**Case #BZA24-000008**  
**Kiawah Island BZA Meeting of June 17, 2024**

**Request:** Variance request for the reduction of the required 15' side setback for approximately 18 square feet encroachment for a proposed bathroom extension located at 35 Painted Bunting, Kiawah Island, SC.

**Staff Review:**

**PLAT OF:**  
**TREE AND TOPOGRAPHIC SURVEY SHOWING**  
**LOT 35 TRACT 11 BLOCK 9**  
**MIDDLEWOODS (411)**  
**PREPARED FOR:**  
**John Logan**  
**LOCATED IN THE TOWN OF KIAWAH**  
**KIAWAH ISLAND**  
**CHARLESTON COUNTY - SOUTH CAROLINA**

2 Proposed Site Coverage  
A-1.00 1" = 10'-0"

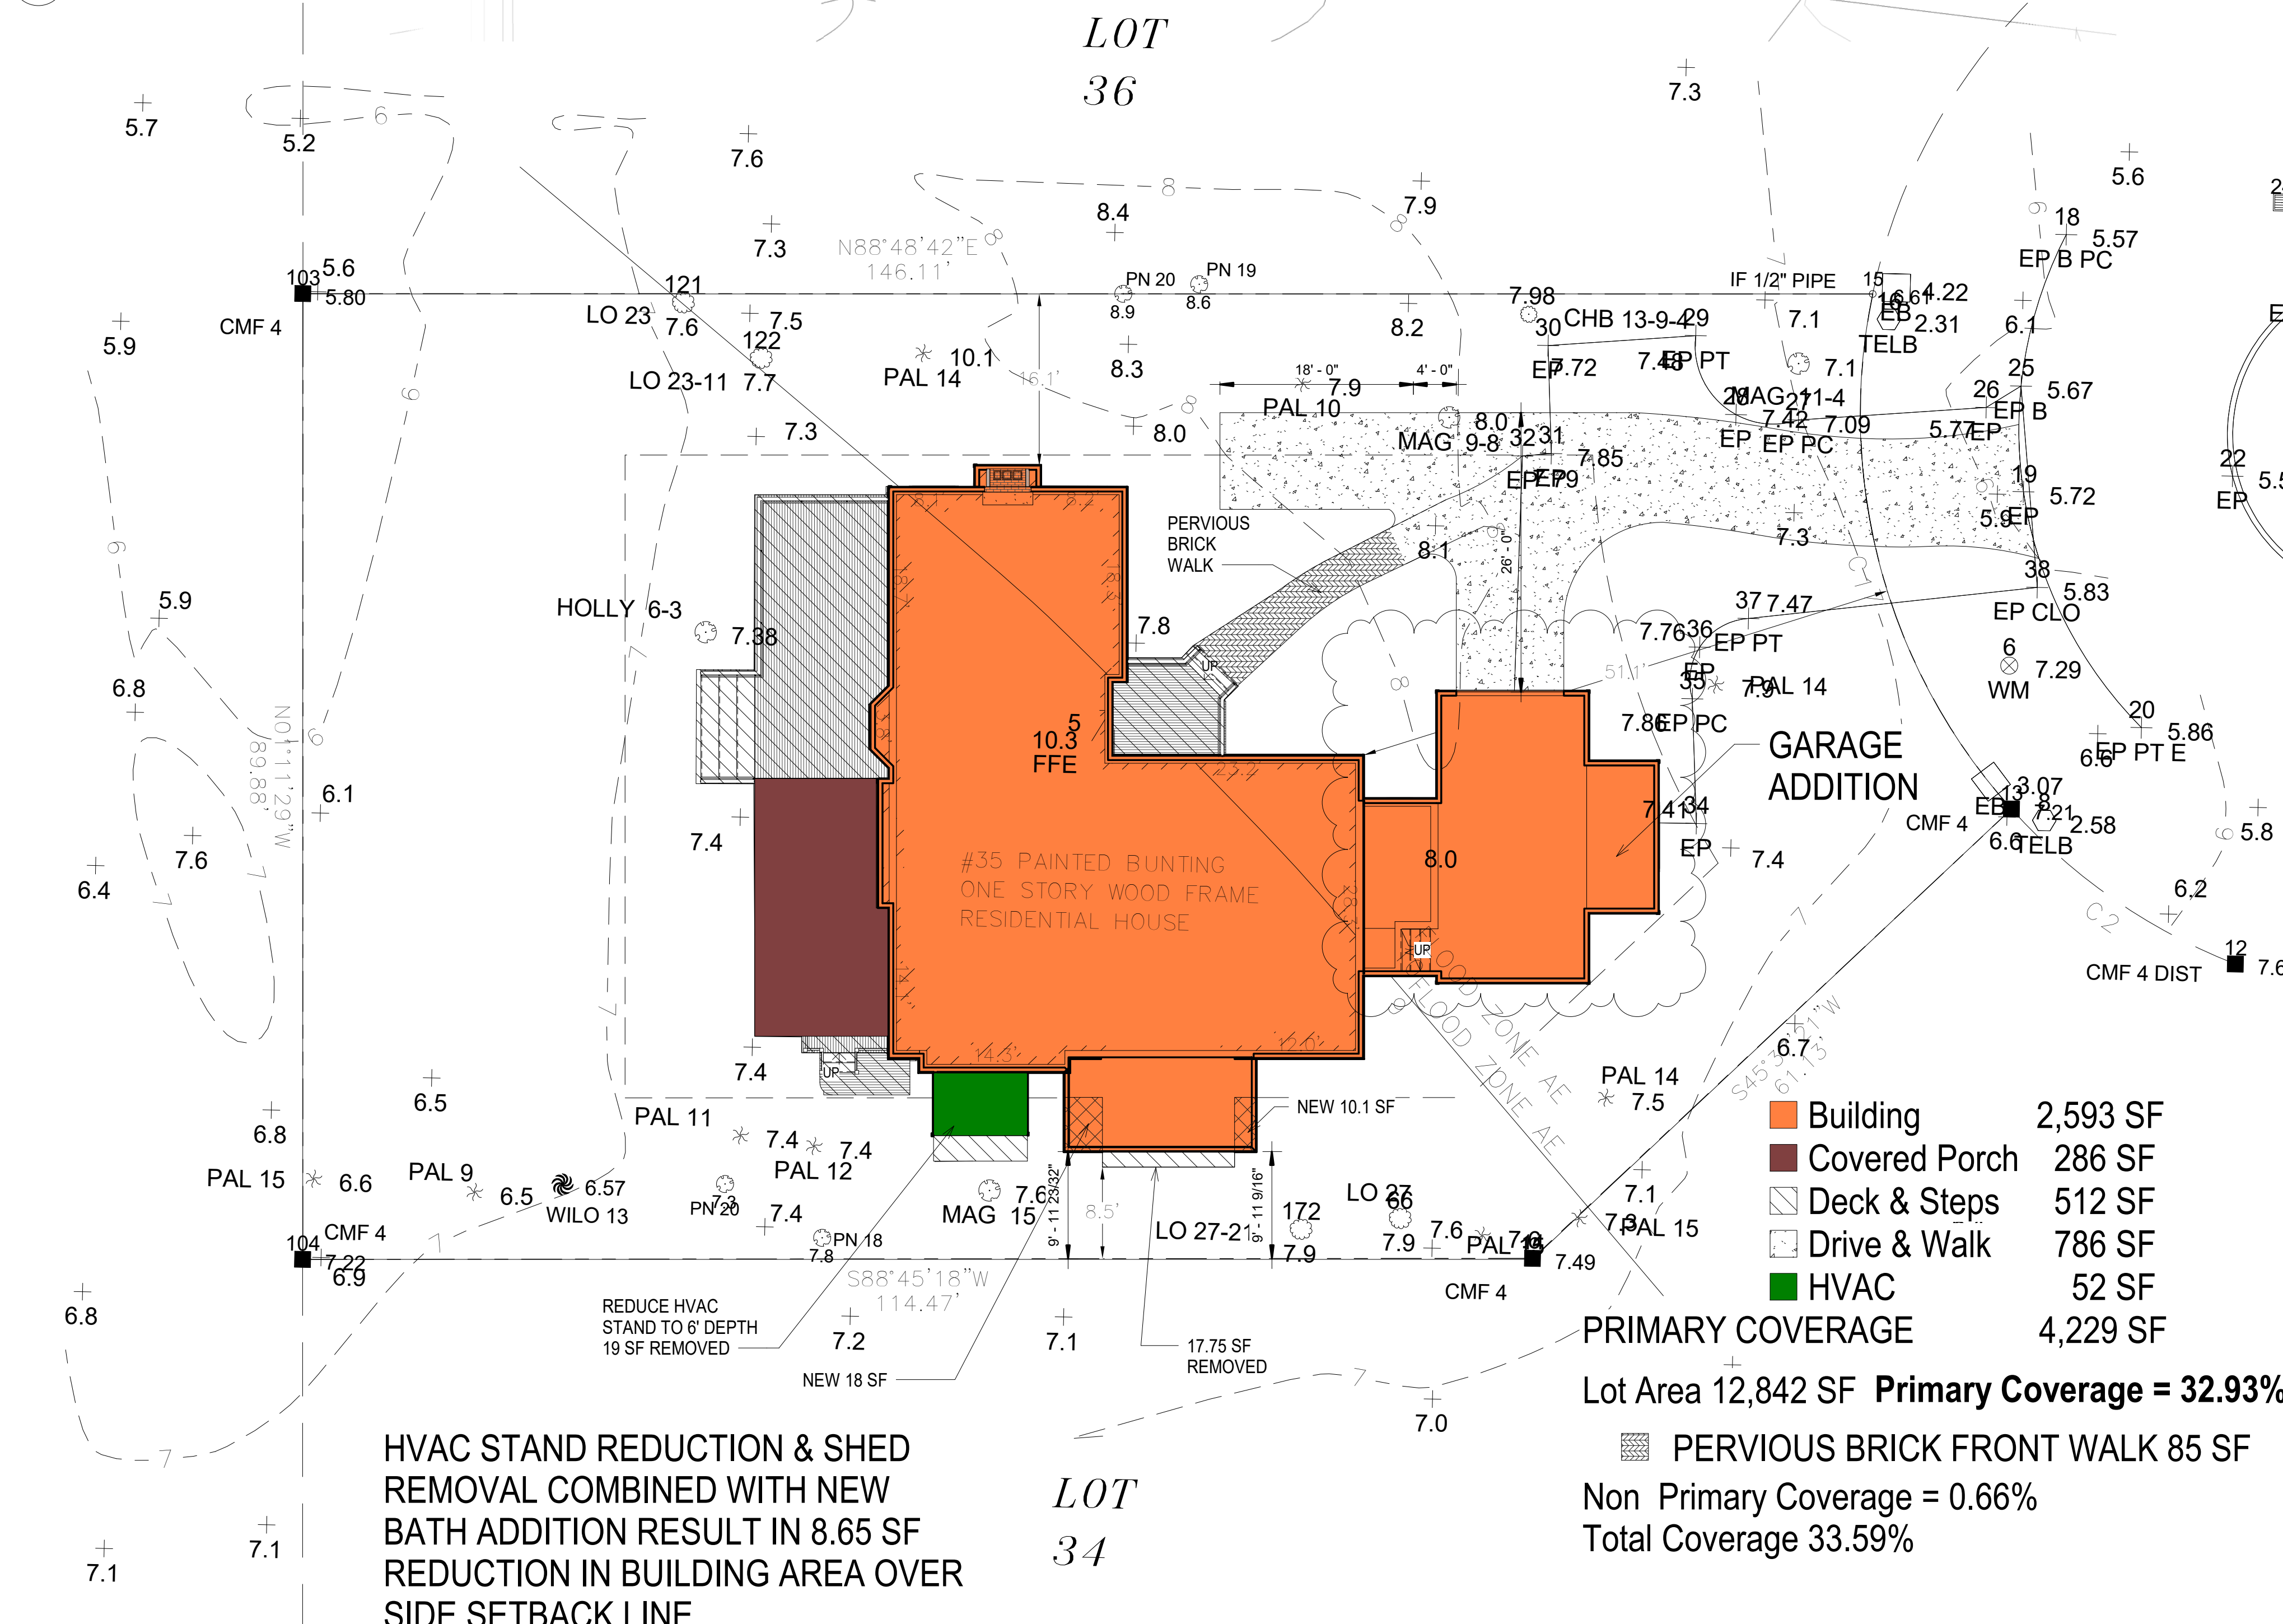
The applicant’s plans include removing the existing shed on the south side of the property (side setback) which will remove approximately 18 square feet and adding a bathroom addition totaling approximately 28 square feet. The applicants proposed plans also include reducing the HVAC stand on the south side of the property which will remove approximately 18 square feet. The net reduction in square feet is approximately 9 square feet. The proposed bathroom addition encroaches into the required setback by approximately 5 feet. The existing shed encroaches into the side setback by approximately 6 feet, 6 inches. The applicants’ plans also include a new garage addition and driveway addition. The existing lot coverage is approximately 31.14%. The proposed lot coverage is 33.59%.

1 Proposed Main Level  
A-1.01/ 1/4" = 1'-0"

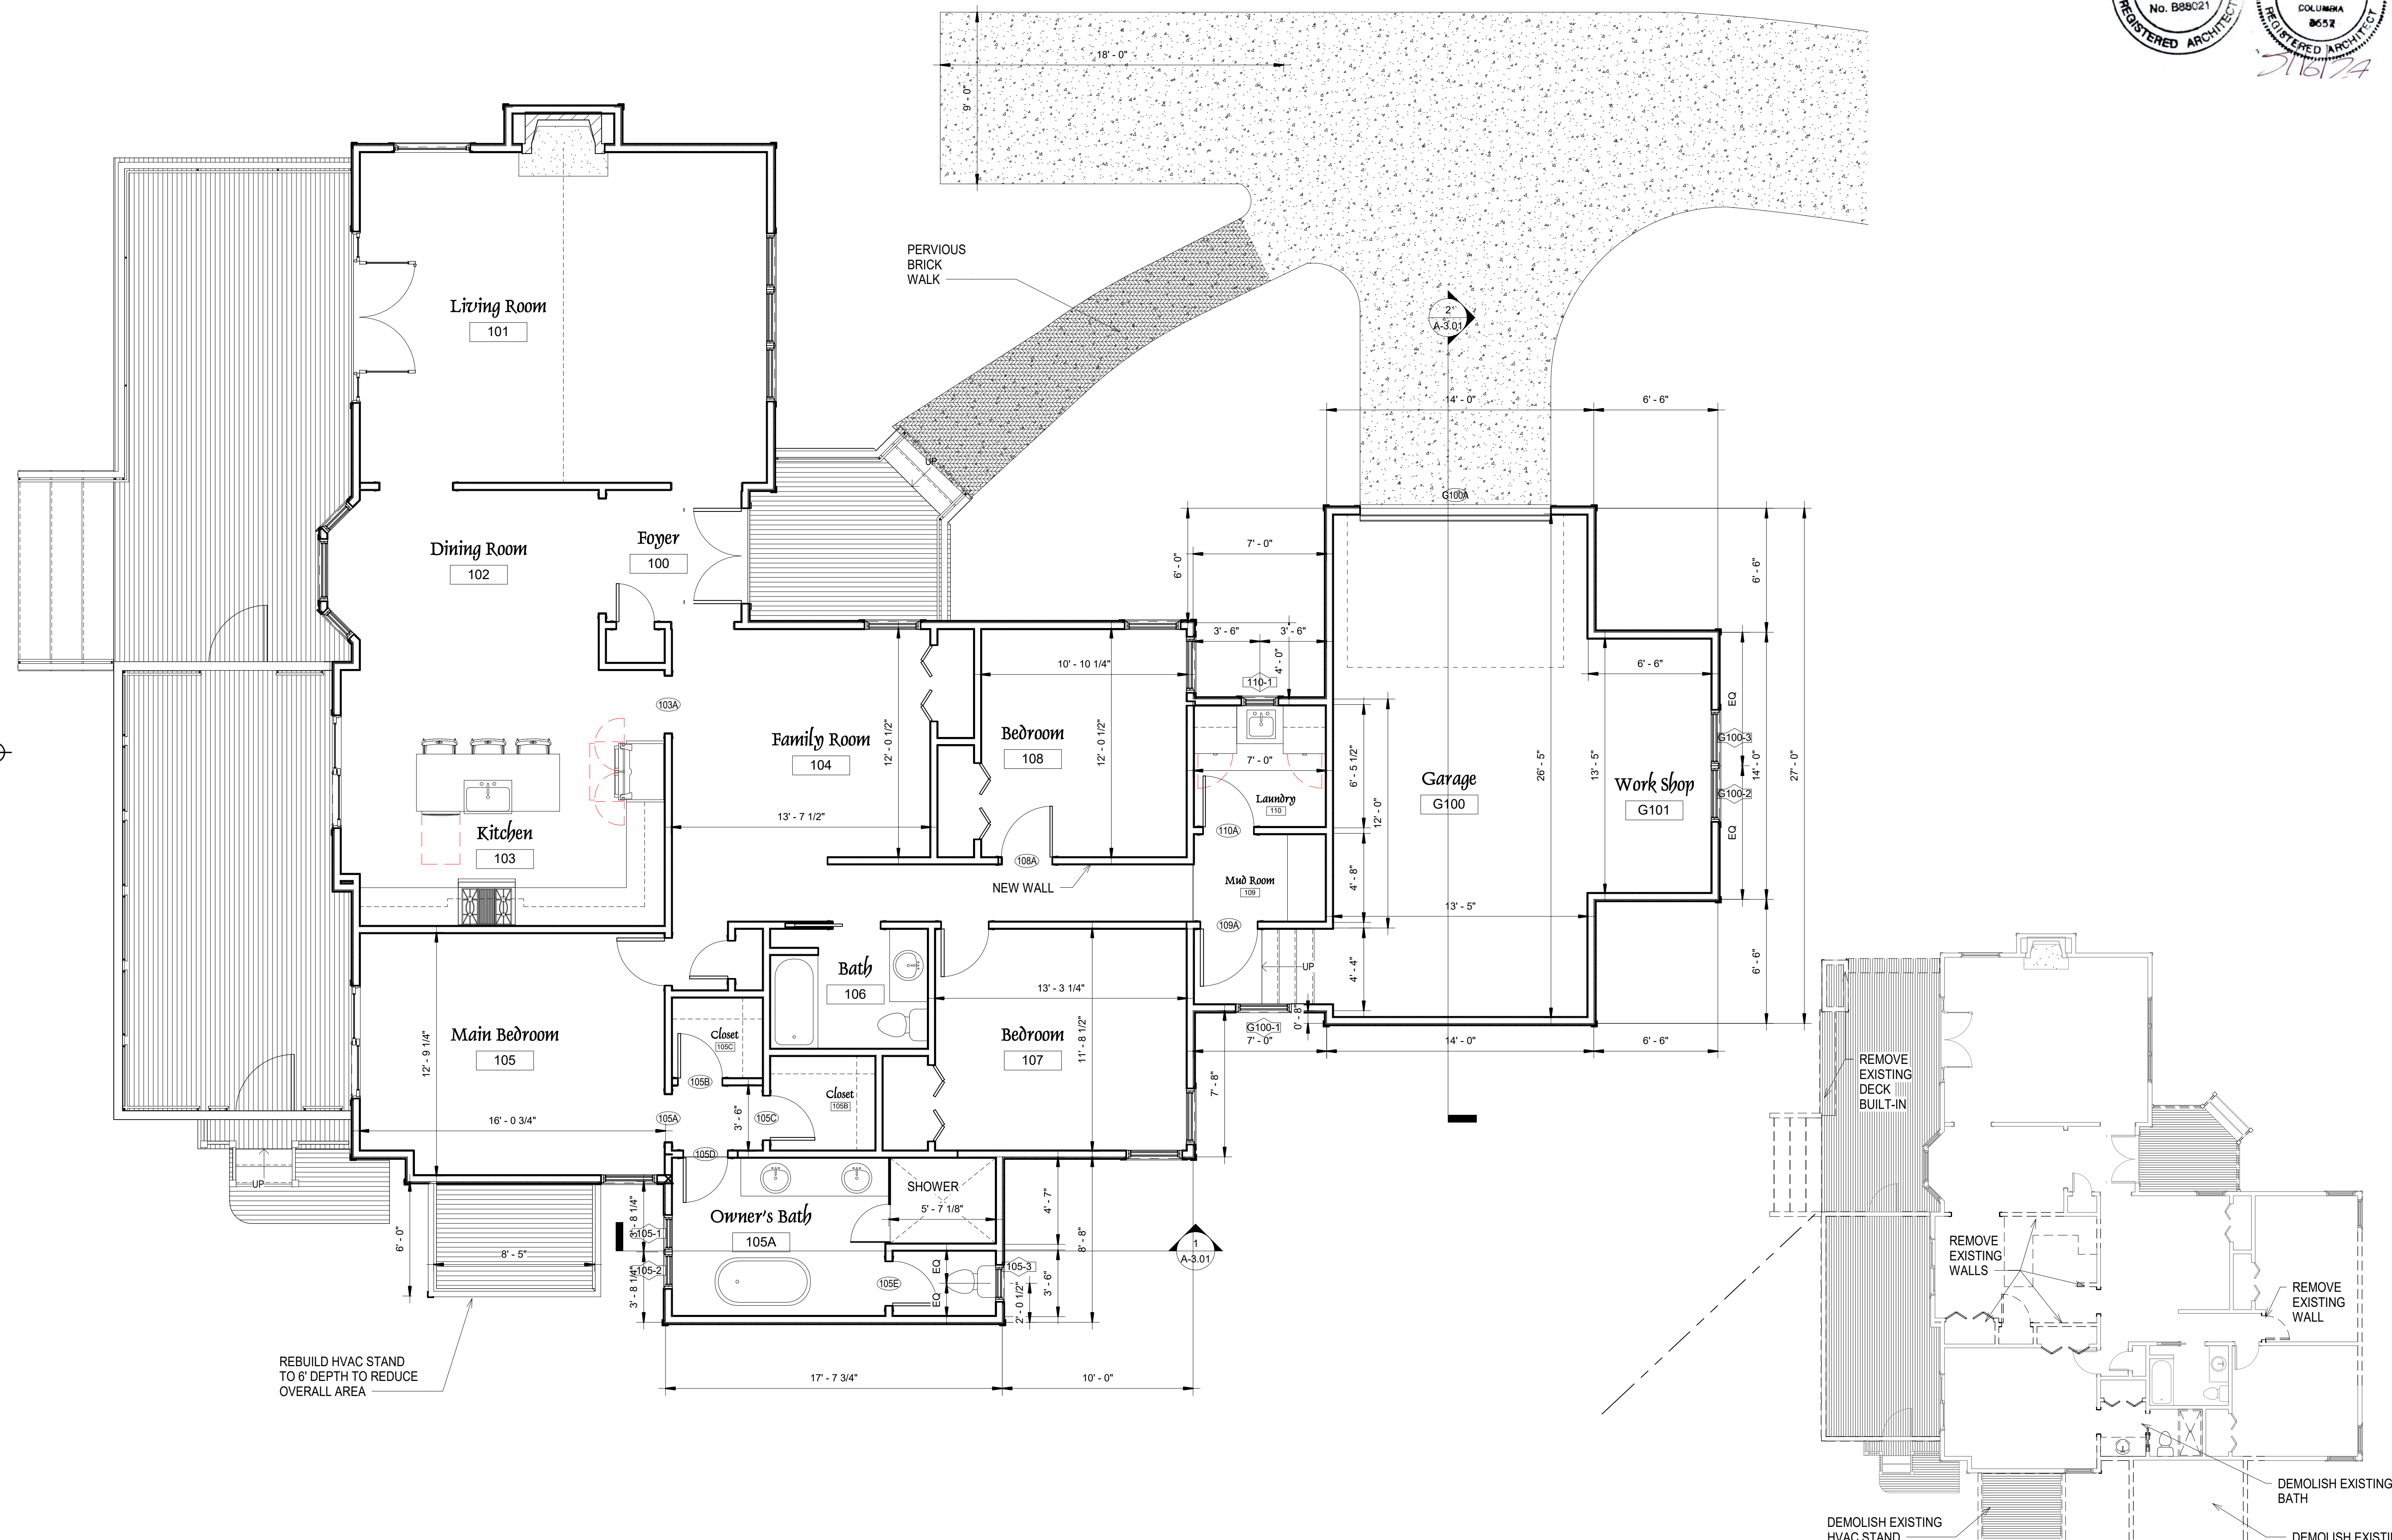
- 
- A1. The Variance is granted with the proviso that there be no windows facing the neighbor. Please revise the design of this piece in your Permit drawings to reflect this.
